**Economic Commission for Europe****Inland Transport Committee****World Forum for Harmonization of Vehicle Regulations****181st session**

**1958 Agreement:****Consideration of draft amendments to existing****UN Regulations submitted by GRSP****Proposal Supplement 18 to the 04 series of amendments to  
UN Regulation No. 44 (Child restraint systems)****Submitted by the Working Party on Passive Safety \***

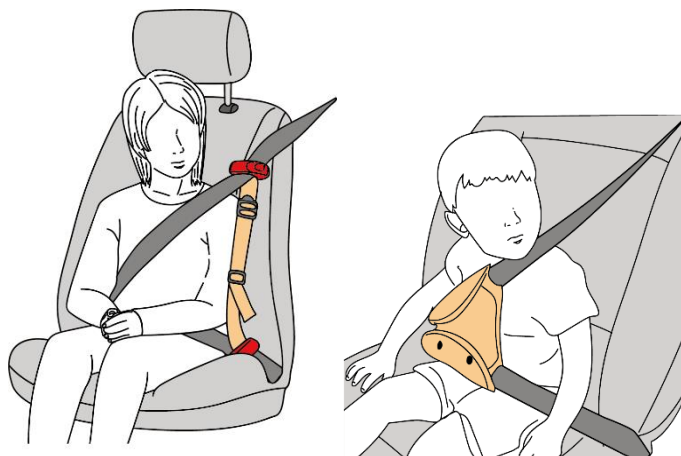
"1.2. This Regulation explicitly forbids child restraint systems in the form of belt guides and other sitting devices that are dangerous and can harm children in the event of a vehicle collision, irrespective of any test results obtained in accordance with paragraph 8.

In particular, it concerns belt guides and sitting devices meant for children of a mass from 15 kg to 36 kg that connect to or attach onto the lap belt portion as well as the torso belt portion of a 3-point adult safety belt system with the aim to alter the adult safety belt routing by for example pulling down the torso belt portion or squeezing together the torso belt portion and lap belt portion. Examples of such non-compliant devices are shown below.
